**Subject: MHI's Response to US-APWR DCD RAI No. 915-6344 Revision 0 (SRP 09.02.01)**

Response to Request for Additional Information No. 915-6344  
Revision 0

**RAI NO.: NO. 915-6344 REVISION 0**

**SRP SECTION: 09.02.01 – Station Service Water Systems**

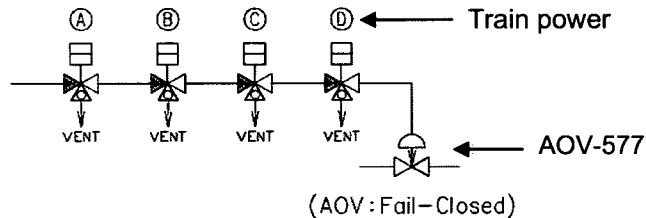
Related to COL Item 9.2(7), Comanche Peak, the COL applicant indicated in a January, 23, 2012, call with the NRC that ESWS safety-related to nonsafety-related boundary valve, AOV-577 (shown on Figure 9.2.1-1, Sheet 1) has four different power supplies.

1. The four different power supplies are not specifically described in the DCD, including Tier 1. The COL applicant stated that this item should be resolved in the DCD and not under COL Item 9.2(7).

2. AOV-577 logic states that this valve closes on ESWS pump stop. AOV 577 logic to close should be clarified and the DCD Failure Modes and Affects Analysis (FMEA) revised, DCD Table 9.2.1-2.

3. DCD FMEA should evaluate boundary valve AOV 577 not going full open. The DCD applicant should determine if there a safety feature for this valve to remain open. For example, if the valve fails closed during power operations, the UHS basin chemistry may not be able to be maintained.

4. DCD FMEA should evaluate VLV-544A/B/C/D (blowdown bypass) being open with single failure of AOV 577 not fully closing (which might occur if there were a bent valve stem).

5. Not all boundary valves are listed in the DCD FMEA when compared to the Comanche Peak COL FMEA.

1. AOV-577 has 4 pilot valves that are supplied electric power from different trains, as shown below. A, B, C and D Class 1E DC-buses power AOV-577, and when power is lost to any of the buses, AOV-577 closes.

2. AOV-577 is a fail-closed valve, and closes automatically on a low basin water level signal, ECCS actuation signal, UV signal or ESW pump stop signal. Closure isolates non-safety-related portions to maintain the required UHS basin inventory for a minimum of 30 days without makeup water. Valve closure also precludes system inventory drain down which may lead to water hammer at pump restart. The valve position is indicated in the MCR. As indicated in the response to Item 5, the valve is not included in the DCD failure mode and effects analysis (FMEA) because it is not part of the standard design.

3. The safety function of AOV-577 is to isolate the UHS blowdown line to ensure that the UHS basin inventory required for cooling the unit for a minimum of 30 days without makeup water is maintained. Either AOV-577 and HCV-010,011,012,013-S or AOV-576 A/B/C/D-S can perform the safety function to isolate the UHS blowdown line. Conversely, opening AOV-577 is not a safety function. If AOV-577 fails closed, the UHS basin water chemistry wouldn't be controlled; however, controlling basin water chemistry is not required during an accident and AOV-577 is designed to close during an accident, as stated in the response to Item 2. The function of AOV-577 for water hammer prevention is also not a safety function because it is not related to accident mitigation. As indicated in the response to Item 5, the valve is not included in the DCD failure mode and effects analysis (FMEA) because it is not part of the standard design.

4. The postulated failure resulting in a blowdown bypass could be terminated by operator action. The effect of uncontrolled blowdown for 30 minutes on basin inventory is insignificant. For example, Comanche Peak Nuclear Power Plant, Units 3&4 COLA Rev. 3, Part 3, Table 3.3-1 describes that the maximum blowdown flow rate is 515 gpm per unit. Blowdown water volume for 30 minutes is 15,450 gallons, which is less than 1% of the total required basin water volume of approximately 8.40 million gallons per unit. When EWS-HCV-010, 011, 012, 013-S or VLV-544A/B/C/D (blowdown bypass valve) is open with a single failure of AOV-577 not fully closing, an operator has sufficient time to close the appropriate valve(s) to terminate an uncontrolled blowdown.

5. In general, components within the scope of the standard design are described in the DCD and those within the scope of the site-specific design are described in the COLA. For example, AOV-577 was not described in DCD Revision 3 as it is within the scope of site-specific design. However, it will be included in the next revision of the DCD in Figure 9.2.1-1 as conceptual design information (Reference UAP-HF-11235, dated July 27, 2011). As stated above, AOV-577 is not included in the DCD because it is conceptual design information.
